South Texas Project  
Units 1 and 2  
Docket Nos. STN 50-498, STN 50-499  
Response to Request for Additional Information for the  
Review of the South Texas Project, Units 1 and 2,  
License Renewal Application – Set 31 (TAC Nos. ME4936 and ME4937)

**STPNOC Response to RAI**

Figure 1- Summary of PE Results for Maximum and Average Dealloying Depths

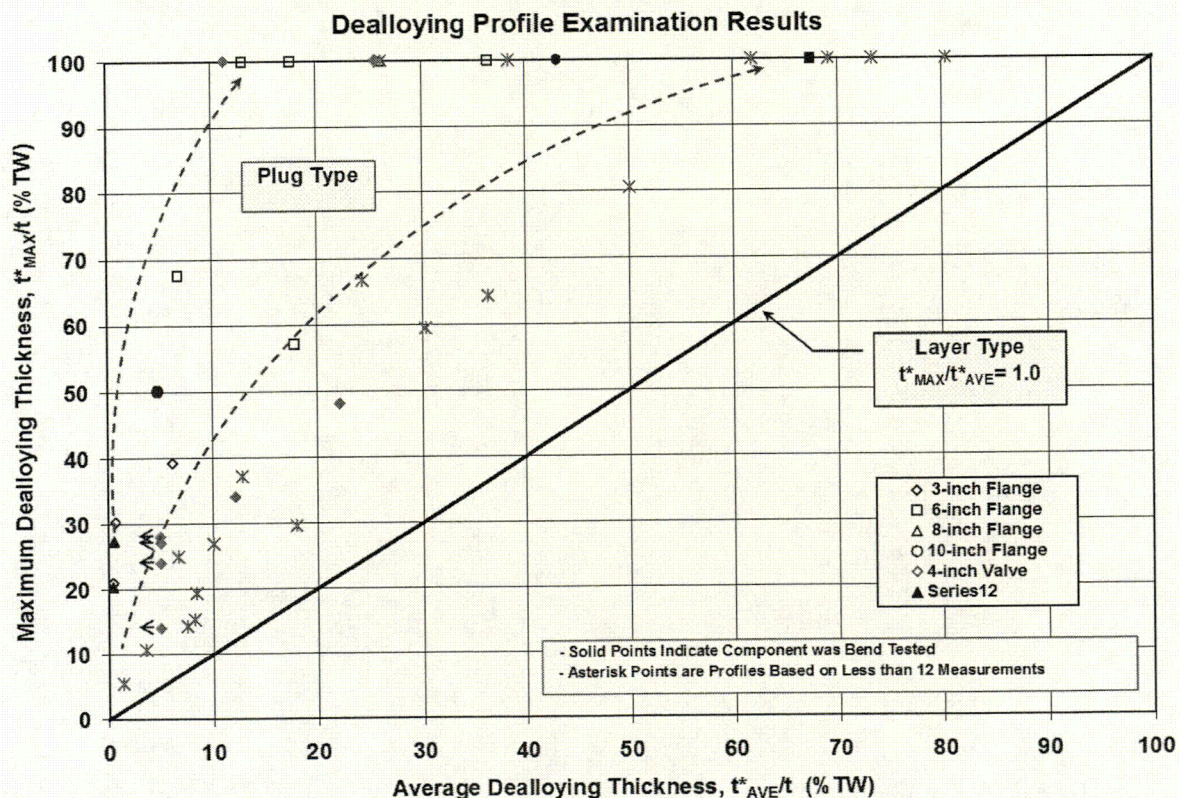
The staff reviewed several reports that show average dealloying values that exceed the 60 percent input used in AES-C-1964-5 during the audit in March of 2015. These values range from approximately 64 to 74 percent, as documented in report numbers MT-3383, "Investigation of Leaks in Aluminum Bronze Flange from South Texas Project to Determine Extent of Dealloying," MT-4907, "Mapping of Dealloying in Aluminum Bronze Pipe to Flange Weld Bend Test," MT-3047-2, "Investigation of Dealloying in 6-Inch Aluminum Bronze Flange and Cracking of this Flange welded to Wrought Pipe at South Texas Project Unit 1," and MT-3923, "Evaluation of [6-inch] Aluminum Bronze Flange from South Texas Project Unit 2 Essential Cooling Water System."

The staff cannot conclude that the applicant's existing structural integrity calculations remain valid when some inspections have revealed average dealloying values that exceed the 60 percent value used in the current analysis.

Explain how structural integrity is demonstrated when inspections have revealed average dealloying values that exceed 60 percent.

Figure 1 below shows a plot of the current PE data where the maximum dealloying depth is plotted against the percent average dealloying depth. The current data base of PE data support the profile shapes are plug-like (localized TW penetration) rather than layered type (uniform TW penetration). There are five PEs that show percent average depths greater than 60%, four, shown as red asterisks, are PEs determined from only 8 data points at 45-degree uniform spacing. The remaining PE had a percent average dealloying depth of 67% which was from a 6-inch flange where an ACT was performed. This flange had a bending capacity that exceeded the integrity model prediction, with margin, providing evidence that the flaw evaluation method is conservative for  $t^*_{ave}/t$  of a percent average dealloying thickness of at least 60%.

Figure 1- Updated Figure 4-1 from AES-C-1964-5

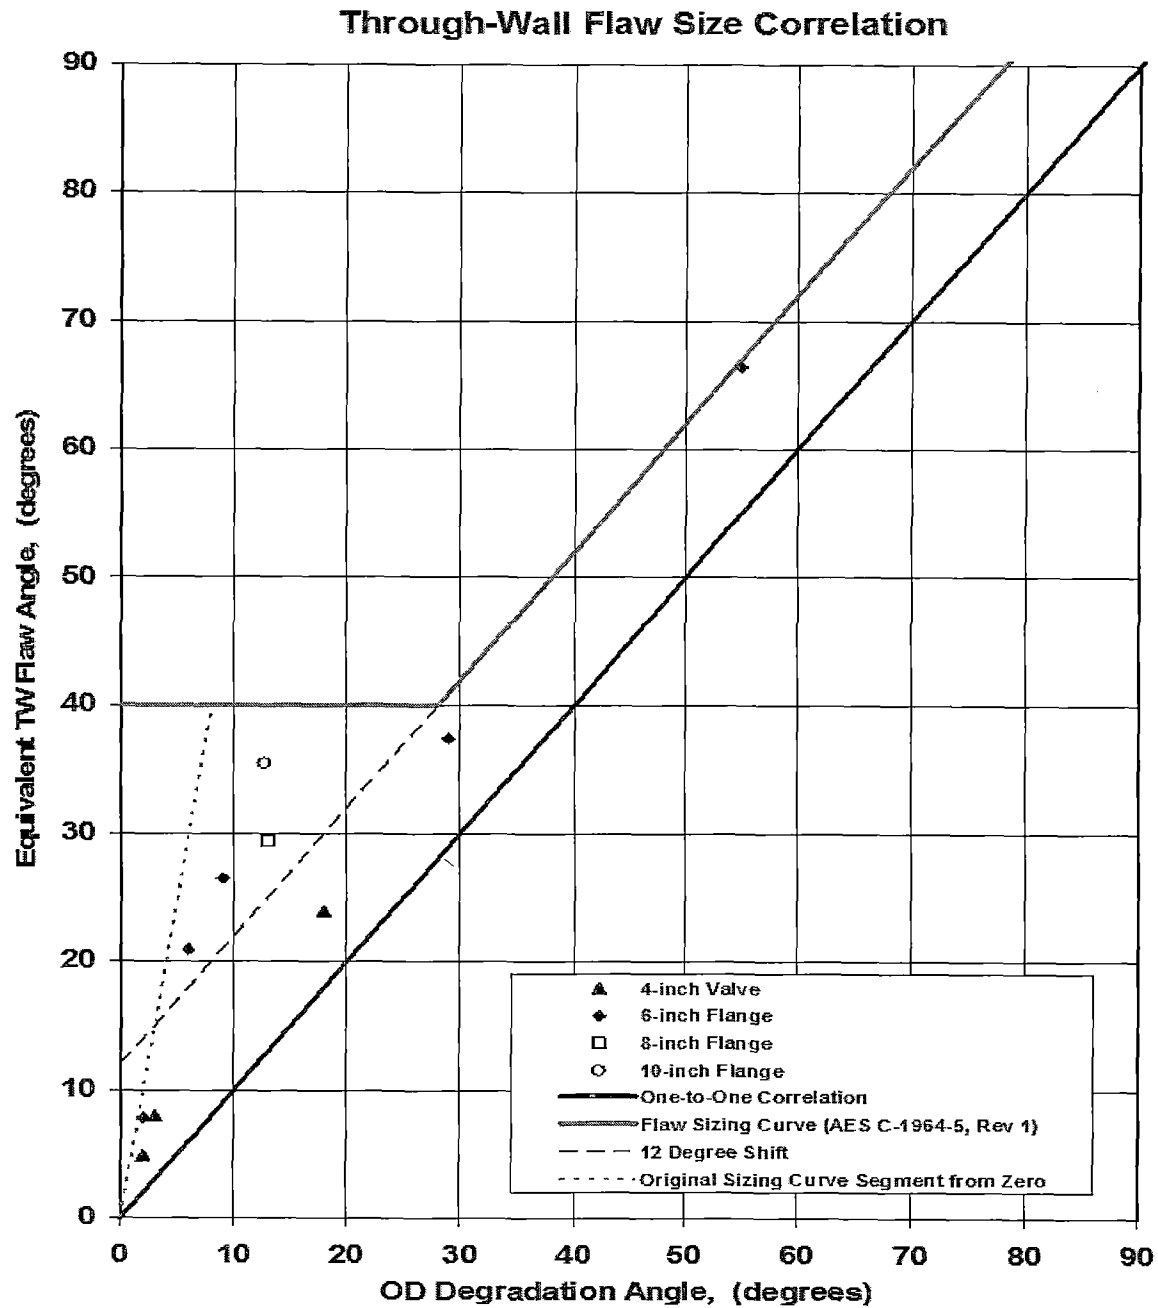
During the audit, the staff found that other piping specimens that exhibited dealloying and through-wall cracks have since been tested; however, the new examination data from these tests has not been used to update or justify the continued use of Figure 4-1 of AES-C-1964-5.

Plot the data for all of the more-recent tests of dealloyed specimens with through-wall cracks onto Figure 4-1 of AES-C-1964-5. Justify the continued use of this figure if the new data points fall outside the existing relationship established between crack angle and dealloying angle. Provide a list of all the data points referenced to their source document.

AES-C-1964-5, Figure 4-1 was updated with the data to date shown in Table 1 below. The updated Figure 4-1 is attached as Figure 1 to this response. Figure 1 correlates the angle of the assumed TW flaw for input to the analytical integrity evaluation with the outside surface length measurements determined from field inspections. The definition for TW flaw angle was revised from the average of the inside and outside dealloying measurements to one based on the equivalent degraded area of the TW dealloyed region. In this revised definition, the angle of the assumed TW flaw provides the same area loss as the local dealloying (plug) region that has penetrated through the wall. This definition has a physical basis in that it is a direct measure of the local area loss and conservatively assumes no load carrying capacity of the dealloyed metal. The local dealloyed area is calculated by numerically integrating the profile depth measurements from each PE.

The original curve for the TW size correlation is shown in Figure 1 as the thin dotted red line connecting with the solid red line. The newly added data fall below the original curve so no adjustments to the original curve were needed. This is the case whether average dealloyed angle or equivalent area angle definitions were used in the correlation. However, for small outside surface degradation (i.e., less than 8 degrees), the thin dotted red line was deleted and the solid red line was extended horizontally to the vertical axis. So for surface measurements less than or equal to 28 degrees of outside circumference, the assumed TW flaw length to be

Figure 1 - Typical Surface Area Scan Chemistry Results for CA952 CTOD Specimen

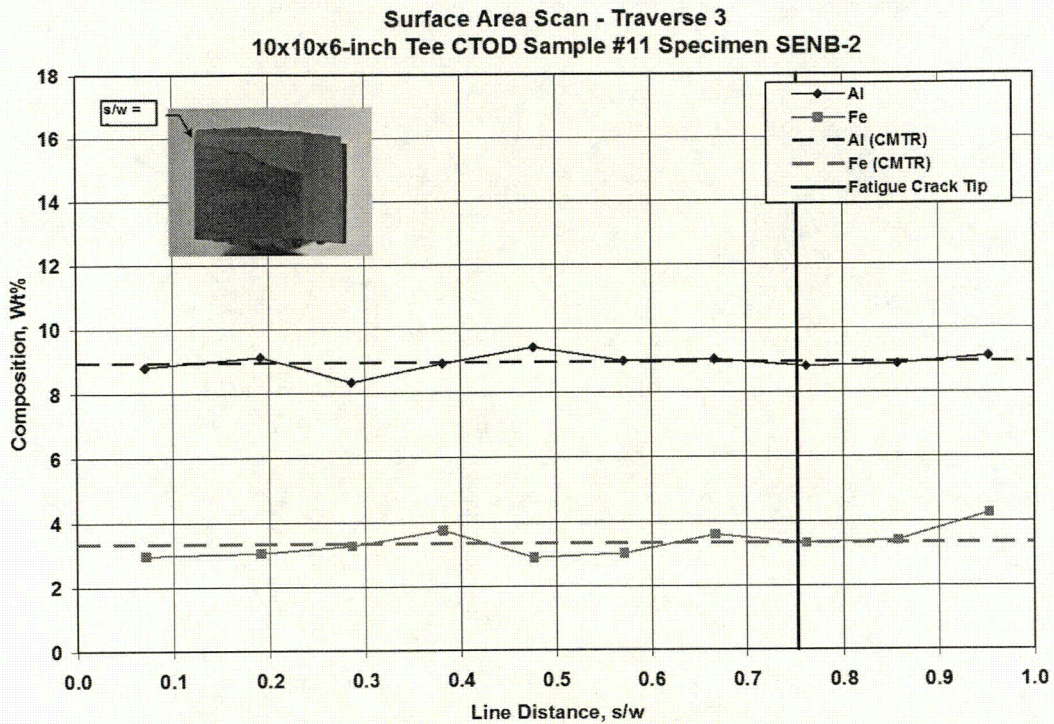
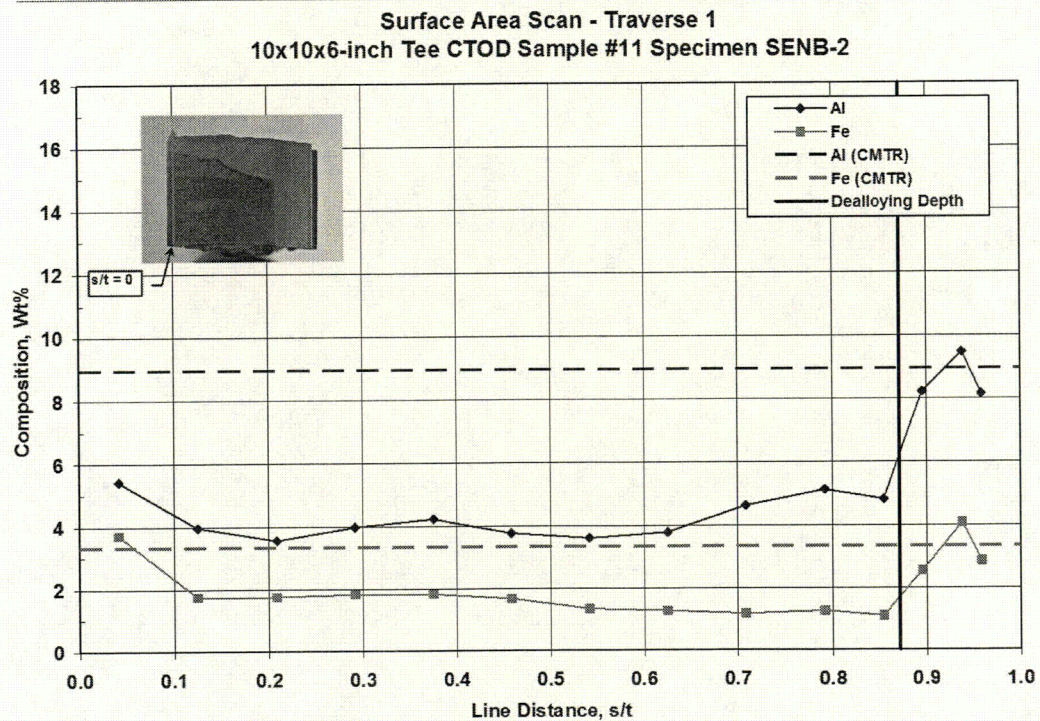
The staff has not been provided with a technical basis to substantiate the assumption that alloys susceptible to selective leaching only exist in two discrete conditions. The staff cannot conclude that the susceptible material only exists in two discrete conditions or that the dealloying process has gone to completion in a region of reduced aluminum/iron based on a single traverse taken on a single specimen. The staff recognizes that material in the fully dealloyed condition will still have measureable amounts of aluminum and iron because not all of the phases present in the alloys are affected by the dealloying process. It is unclear to the staff if conclusions being drawn from Energy Dispersive Spectroscopy (EDS) traverses in dealloyed regions are based on elemental levels, degree of stability of the composition over a given length, or some other factor.

1. Provide the technical basis used to substantiate the assumption that the alloys (C95400 and C95200) susceptible to selective leaching only exist in two discrete conditions; the as-received condition and fully dealloyed. Provide the technical references and experimental data used to support the technical basis, as applicable.

- b) The corrosion process progresses through the thickness like a moving wave. The boundary of the penetration follows the interconnecting network transformed material between the non-susceptible alpha grains. There is a distinct and abrupt change in material surface composition between the two regions. This can be seen in Figure 1 for CA952 and Figure 2 for CA954.

- e) Examples of typical results are shown in Figures 1 and 2. Figure 1a confirms the surface chemistry within the undealloyed region is consistent with the virgin material since the aluminum (Al) and Iron (Fe) content is close to the chemistry material test report (CMTR) values reported for this CA952 heat. Figure 1b shows the reduced Al and Fe contents within the dealloyed region and the return to virgin composition values in the undealloyed layer. Figure 2 illustrates the same behavior for dealloyed and undealloyed material for CA954.

Figure 5 - Image Showing Side-View of Fracture Surface of Tensile Specimen (10x10x6  
 -inch Tee, Specimen #3-3, CA952)

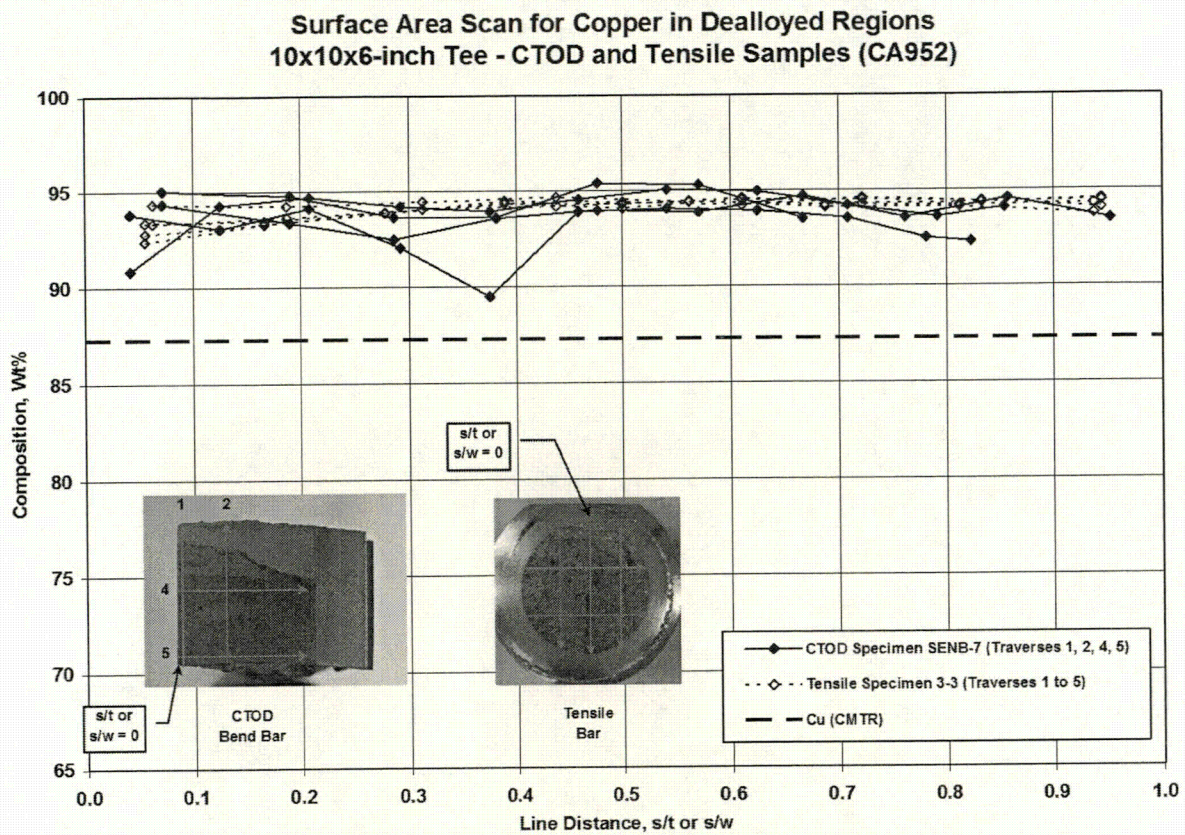
In addition, the elemental composition of the 100 percent dimensionally dealloyed tensile specimen (10x10x6 tee, piece number 3, Alloy CA952) has not been evaluated to determine if the dealloying process has gone to completion. This tensile specimen was used to produce the only yield strength value for 100 percent dimensionally dealloyed material measured to date, as shown in the plots on page 6 of Enclosure 1.

2. Demonstrate that the dealloying process has gone to completion in the tensile specimen (10x10x6 tee, piece number 3, Alloy CA952) used to produce the 100 percent dimensionally dealloyed yield strength value plotted on page 6 of Enclosure 1.
3. Provide, in tabular form, all the specimens that were tested in the 100 percent dealloyed condition. Provide a short description to identify each specimen including the component it was extracted from and alloy. Provide the mechanical properties that were measured from conducting the test. Provide the method used to establish that the specimen was 100 percent dealloyed. If neither the optical method discussed above nor direct elemental evaluation was used to establish that the test specimen was 100 percent dealloyed, provide a justification to substantiate the condition of the material.

The results of the metallurgical analysis are shown in Figure 5. The light micrograph at the top of figure shows that the SEM and light microscopy are directly comparable. It was determined that the visual assessment of the microstructure can be correlated to the chemistry results produced using EDS when a copper colored phase is present in the microstructure. The light micrograph shows a microstructure of  $\alpha_p$  – grains in a network of dealloyed eutectoid ( $\alpha_s$ , copper and voids). Copper is seen as pinkish color material and voids are visible as black holes within the eutectoids.

Figure 1 - CMTR and Test Specimen Data for SB-148 CA954

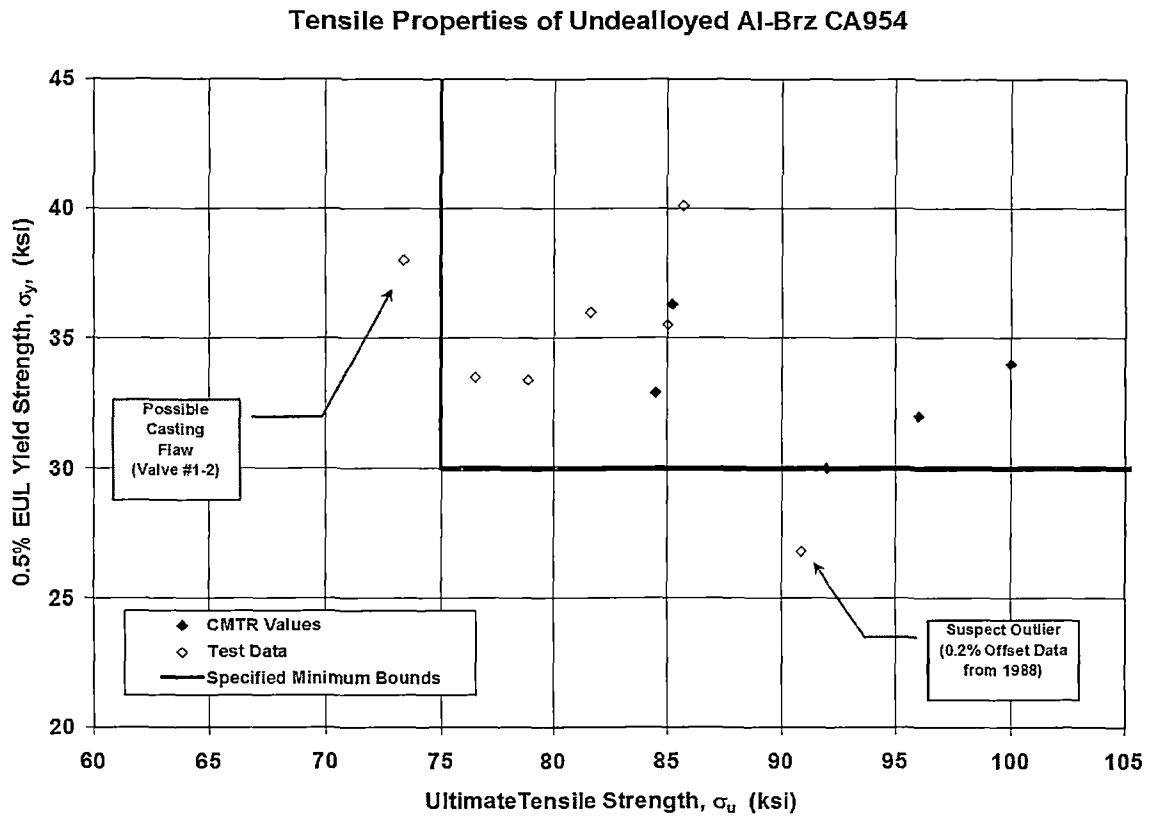
- (4) Tensile testing of material in the zero percent dealloyed condition has produced lower yield strength values than the material tested in the 100 percent dealloyed condition. Also, material tested in the less than 10 percent dealloyed condition produced comparable yield strength values as the material tested in the 100 percent dealloyed condition. Given the degree of scatter and statistical uncertainty in the yield strength values plotted on page 6 of Enclosure 1, it is not clear to the staff that the single yield strength data point for the 100 percent dealloyed material bounds the lower limit which could exist for the susceptible components in operation.

- (4) Provide the lowest yield strength and ultimate tensile strength values measured to date, at any level of dealloying. Clarify what numerical yield strength value is being used for the 100 percent dealloyed material in the structural integrity calculations to support operability evaluations. State and justify the basis used to conclude that the 100 percent dealloyed yield strength value being used for the structural integrity calculations to support operability evaluations is bounding for the susceptible components in operation.

Figures 1 and 2 compare CMTR data with tensile tests results produced by STP. In general, there is good agreement between the test data and reported CMTR values for the tested components. There are a few cases where the ultimate tensile strengths fell on the low side of the specified minimum values for the specification. Two of the specimens showed casting imperfections on the fracture plane typical of solidification flaws. Such small imperfections can have a noticeable impact on test results derived from sub-size specimens.

There is one test result for CA954 in the virgin condition that produced a 0.2% OS yield value that is lower than the tensile results at 100% DA condition. This result is listed in the table above (and plotted in Figure 1) where it is noted that this test result is suspected to be an outlier for the following reasons. First, the yield value falls below the specified minimum yield for CA954 yet it exhibited a high value for ultimate tensile strength. This appears to be inconsistent for CA954 which obtains its strength from larger amounts of transformed material. Second, the determination of 0.2% OS requires an accurate estimate of modulus of elasticity. Variability in E for low modulus materials like Al-Brz can cause significant scatter in 0.2% OS yield values. If an upper value for E was assumed, then the yield strength will be underestimated. In either case, the 0.2% OS yield strength is not directly used in the flaw evaluation of in-service dealloyed castings.
